MATANUSKA-SUSITNA BOROUGH PLATTING BOARD AGENDA

**APRIL 1, 2021
REGULAR MEETING
1:00 P.M.**

PRELIMINARY PLAT: **STELLA RIDGE MASTER PLAN**
LEGAL DESCRIPTION: **SEC 18, T18N, R1E, SEWARD MERIDIAN, AK**
PETITIONER: **JERRY HARMAN**
SURVEYOR/ENGINEER: **HANSON LAND SOLUTIONS**
ACRES: 60.0 PARCELS: 51
REVIEWED BY: CHERYL SCOTT CASE: 2020-098

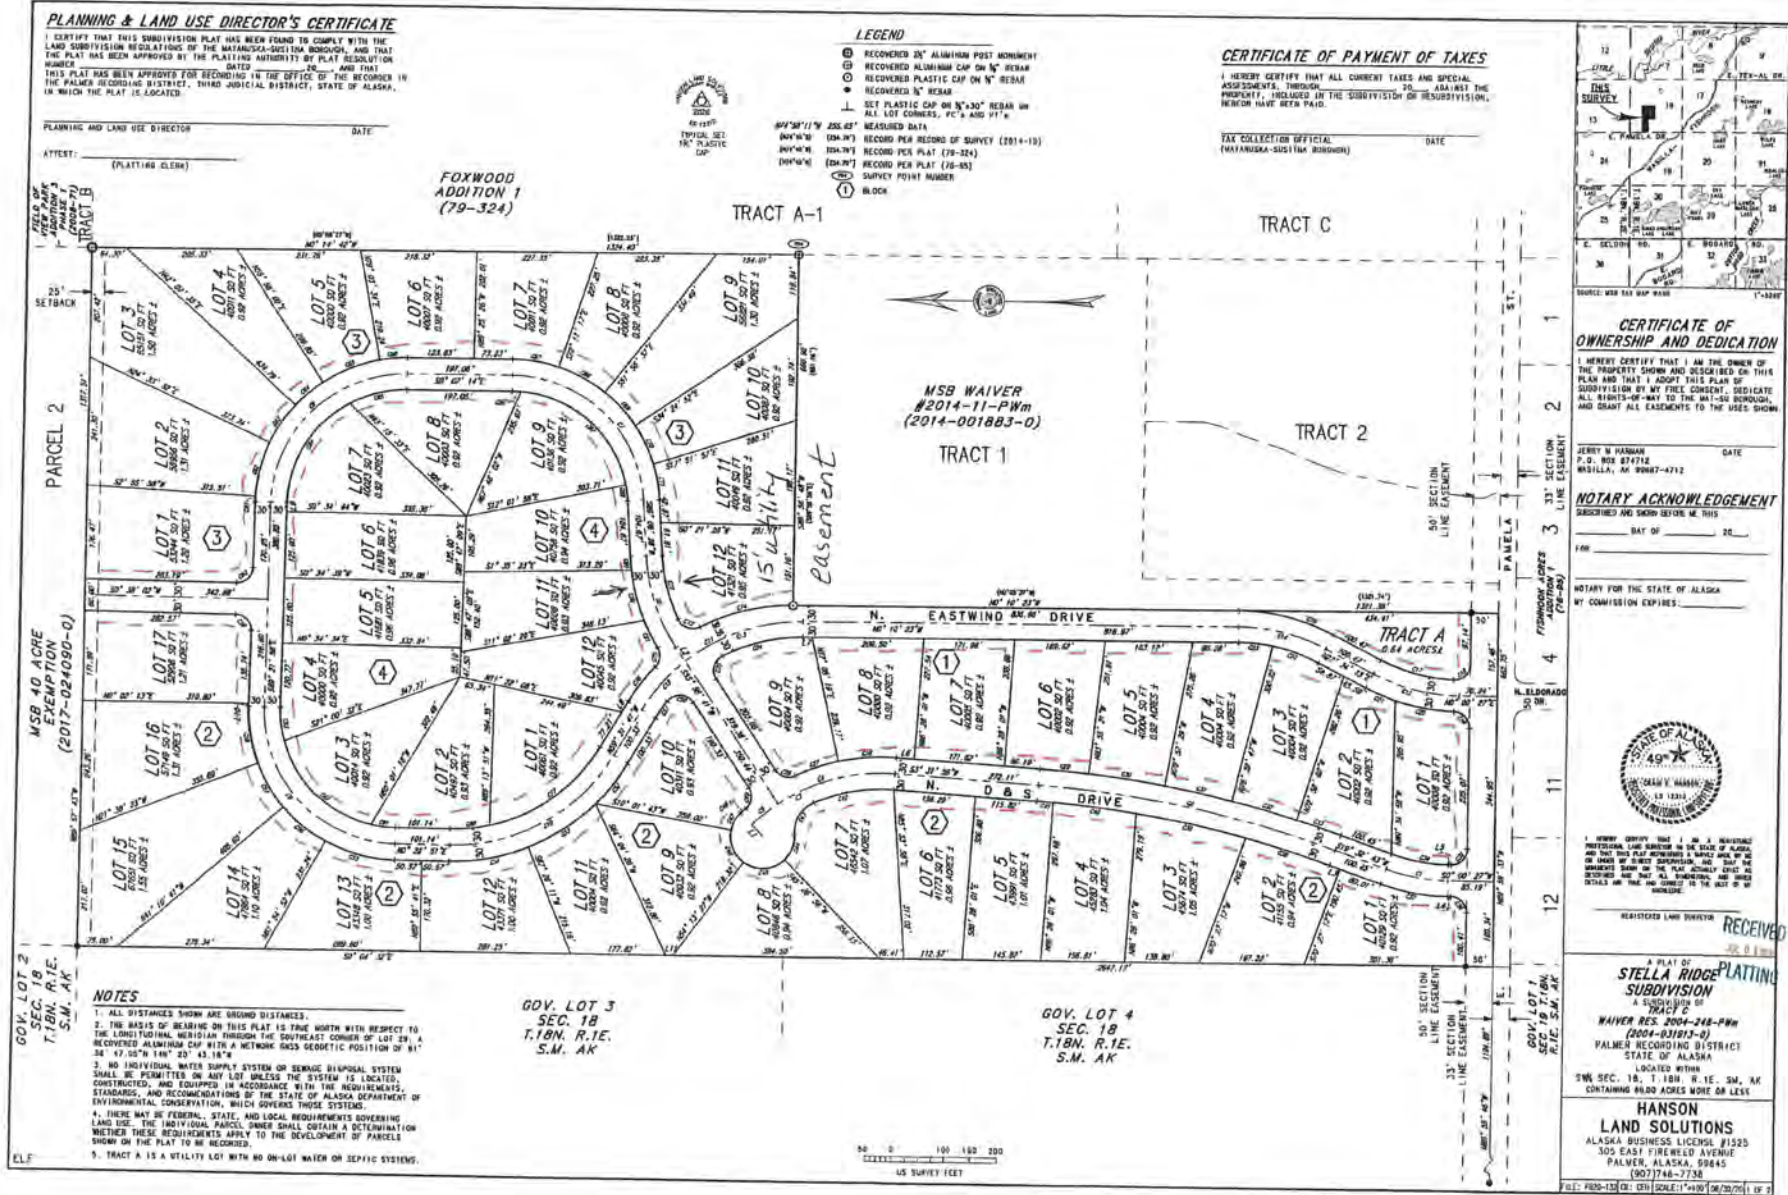
MEA comments to include a 15 feet wide utility easement along all road right-of-way's as shown on the attached drawing.

MEA & MTA requested a 15' wide utility easement along all road rights-of-way as shown on MEA's drawing. **(Exhibit O)** *Staff notes the 15' utility easements are shown on the preliminary plat.*
